**Re: Agenda Item 11E – Supplemental Comments on Duke Warehouse at Patterson Avenue and Nance Street Project – Final Environmental Impact Report (SCH No. 2022010274)**

**Subject: Comment Letter on Duke Warehouse At Patterson Avenue and Nance Street, Perris, California, Draft Environmental Impact Report SCH No. 2022010274**

**Figure 3: 40 Mile Radius From Duke Warehouse Project Site**

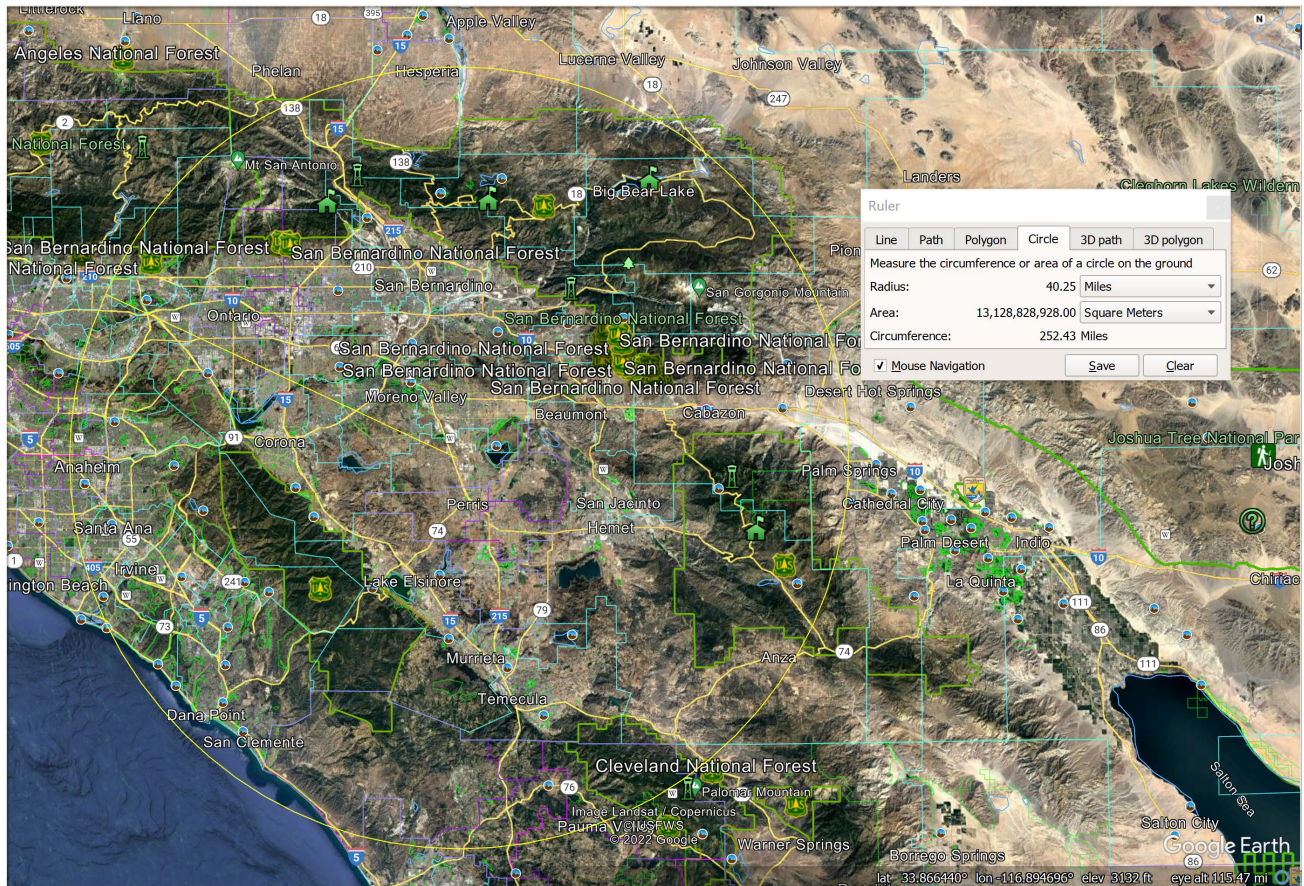
**3. The Average Truck Trip Length Of 40 Miles Used In The Air Quality Analysis Does Not Match The Length(s) Used To Support Other Duke Warehouses.**

According to the operations air quality analysis of Project,<sup>6</sup> SCAQMD requires that truck trip length should be set to 40 miles in CalEEMod. This statement does not comport with the reality of where warehoused materials will ship from in the region. The 40-mile distance is insufficient to allow vehicles to travel to the major ports in the Southern California region – Los Angeles and Long Beach.

In its 2019 DEIR of the Duke Realty Alabama and Palmetto Warehouse Project, SCH 2019029078, submitted to the County of San Bernardino, an average truck trip length of approximately

The air quality analysis of the Nance/Patterson Project must be updated to reflect the actual distance of the average daily truck trip, approximately 80 miles (the distance to the Port of Los Angeles). Using the 80-mile daily truck trip will nearly double the daily emissions of pollutants associated with the Project, increasing the Regional burden and resulting in a potentially significant impact. The City must address the impact of this issue in a revised DEIR.

**Figure 4: Locations of Duke Nance/Patterson and Alabama/Palmetto Projects**

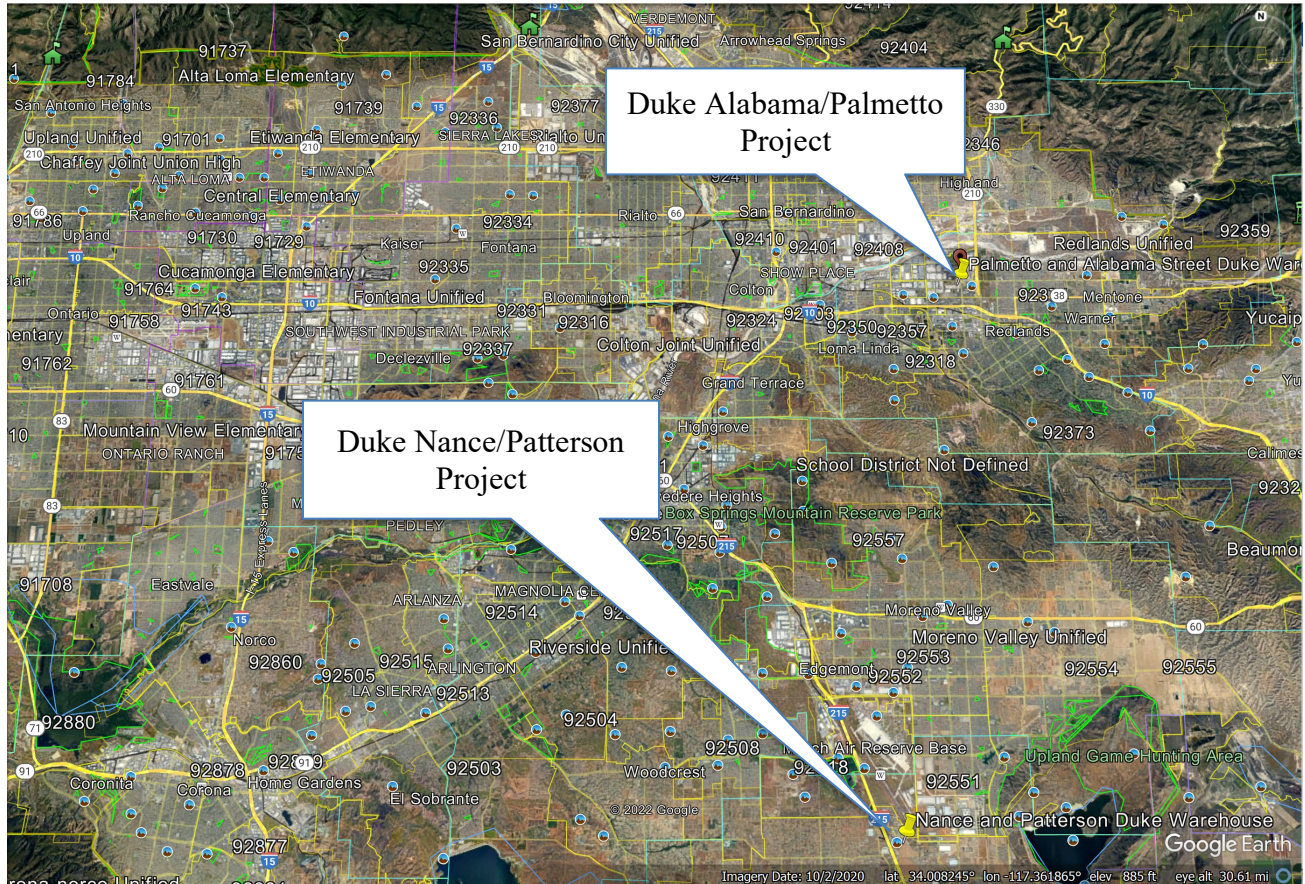
77 miles was assumed, which is the distance to the Ports of Los Angeles/Long Beach.<sup>7</sup> The Alabama/Palmetto Warehouse is located approximately 15 miles north of the Nance/Patterson Project.

**Figure 6: Trip rates per 1,000 square feet as reported in ITE manual**

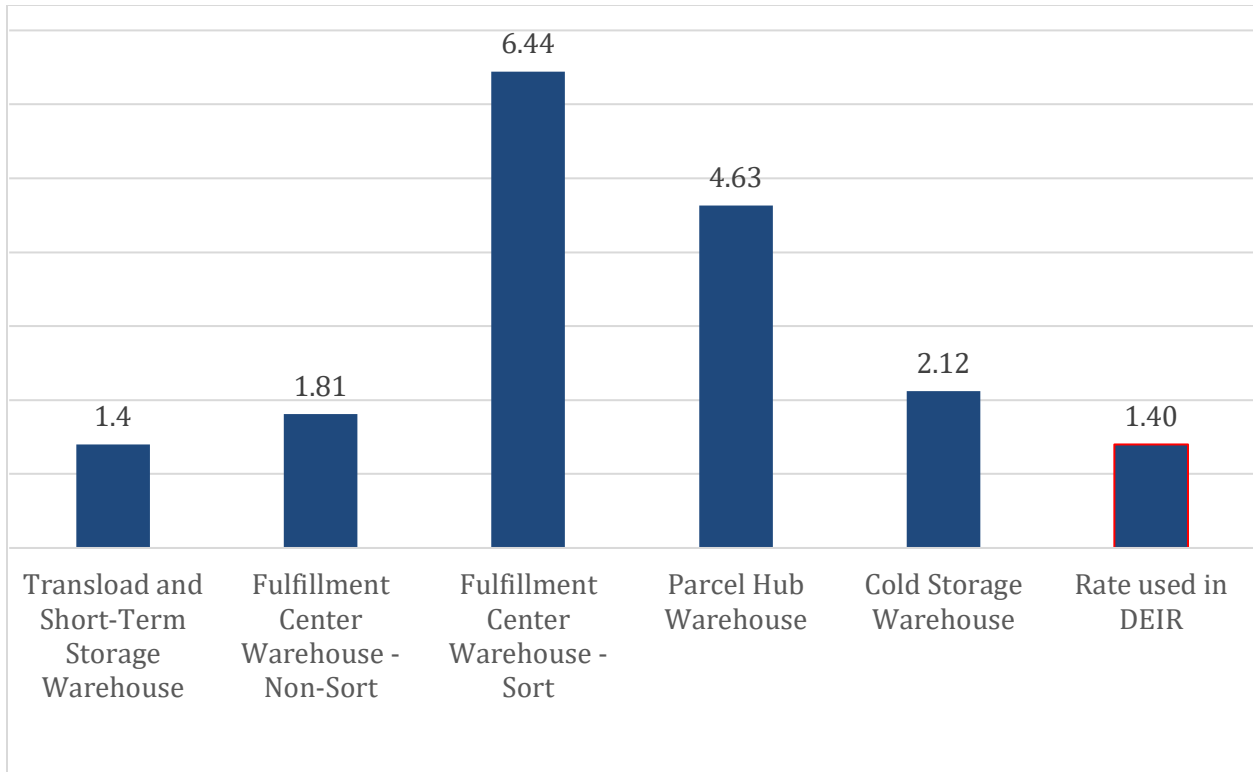
Using the ITE manual rates above, the proposed 749,668 square foot HCW Project could result in 1,050 to 4,828 trips daily.
